Re: SUB 2001-Preliminary Plat of Eck Eighth Addition

STAFF REPORT
(Preliminary Plat)

CASE NUMBER: SUB 2001-38 -- ECK EIGHTH ADDITION

STAFF REPORT
(Final Plat, Preliminary Plat Approved 4/26/01)

VICINITY MAP

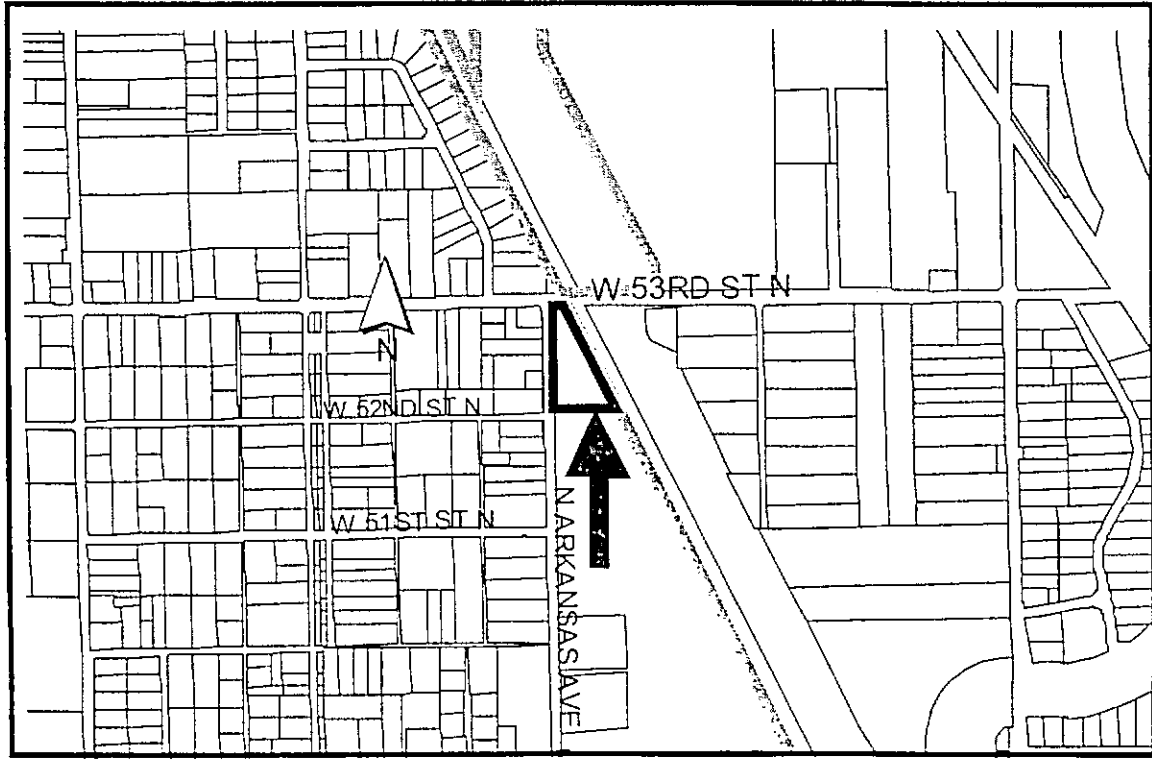
- A. Municipal water services are available to serve the site. In accordance with the zone change, the extension of sanitary sewer is required for the site. The sewer service may be provided from either City of Wichita or Park City. City Engineering needs to comment on the need for additional guarantees or easements.

- C. City Engineering needs to comment on the status of the applicant's drainage concept. If any of this site's drainage is directed onto the adjacent railroad right-of-way, a letter shall be provided from that railroad indicating their willingness to accept such drainage.

- D. Traffic Engineering needs to comment on the need for improvements to perimeter streets.
- E. Traffic Engineering needs to comment on the access controls. The plat proposes two access openings along Arkansas and complete access control along 53rd St. North. The plat denotes 100 feet of complete access control along Arkansas from the 53rd St. North intersection; whereas the Subdivision Regulations require 150 feet of complete access control from arterial intersections. In accordance with the Subdivision regulations, any access openings located within 250 feet of the intersection of Arkansas and 53rd St. North (measured from curb) are limited to right-turns only, and shall be referenced on the face of the plat; or a guarantee provided for the future construction of a raised medial. The final plat shall reference the access controls in the plat's text.

- F. Traffic Engineering needs to comment on the need for additional right-of-way. The Subdivision Regulations require 75 feet of half-street right-of-way at arterial intersections.

VICINITY MAP

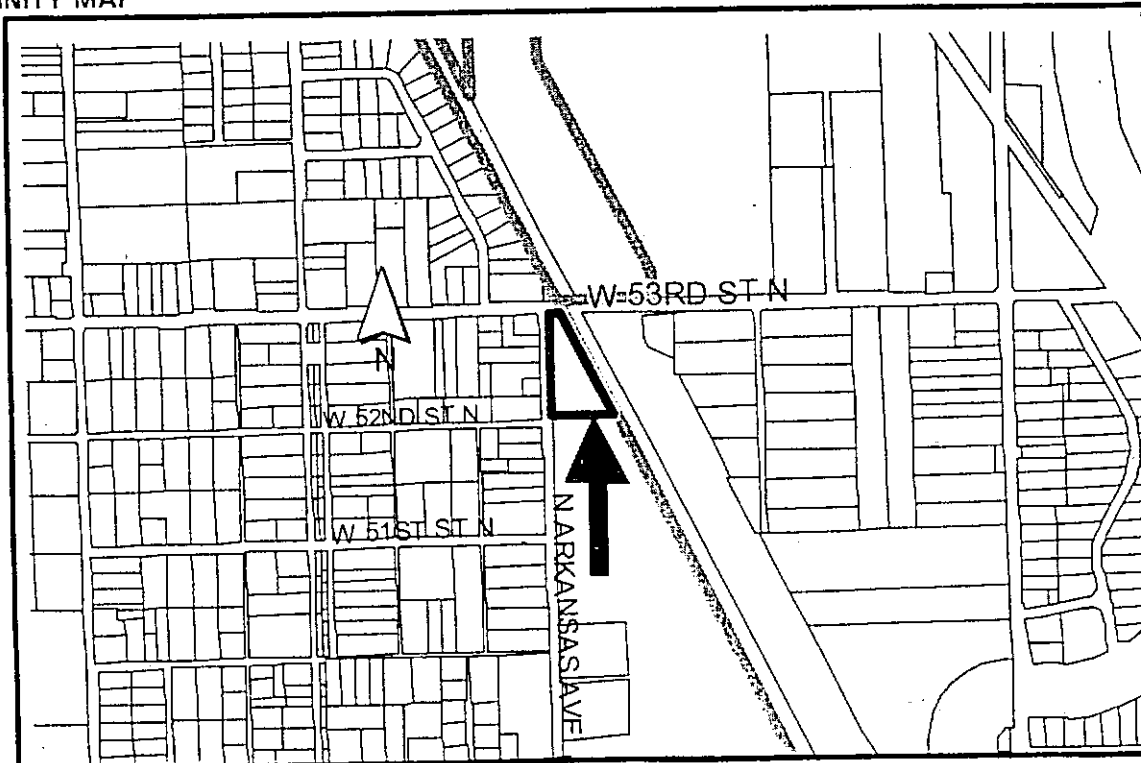
- A. Municipal water services are available to serve the site. In accordance with the zone change, the extension of sanitary sewer is required for the site. The City Water and Sewer Department will not permit sewer service from Park City for this site. The Applicant shall guarantee the extension of City water and sanitary sewer. In lieu of extension of sanitary sewer, the Applicant may install a temporary private system consisting of a grinder pump and private line connecting to the City sewer line. This system would be required to be replaced with City sewer when available to the site.

- C. City Engineering needs to comment on the status of the applicant's drainage plan. The drainage concept indicates a need for on-site detention. For any of this site's drainage that is directed onto the adjacent railroad right-of-way, a letter shall be provided from that railroad indicating their willingness to accept such drainage.

- F. Traffic Engineering needs to comment on the access controls. The plat proposes two access openings along Arkansas and complete access control along 53rd St. North. In accordance with the Subdivision regulations, any access openings located within 250 feet of the intersection of Arkansas and 53rd St. North (measured from curb) are limited to right-turns only, and shall be referenced on the face of the plat; or a guarantee provided for the future construction of a raised medial.

- G. Traffic Engineering needs to comment on the need for additional right-of-way. The Subdivision Regulations require 75 feet of half-street right-of-way at arterial intersections. Traffic Engineering has approved the 60-ft right-of-way with a corner clip.

- S. The representatives from the utility companies should be prepared to comment on the need for any additional utility easements to be platted on this property. **Southwestern Bell and KGE have requested revised language on the plat regarding utility easements.**
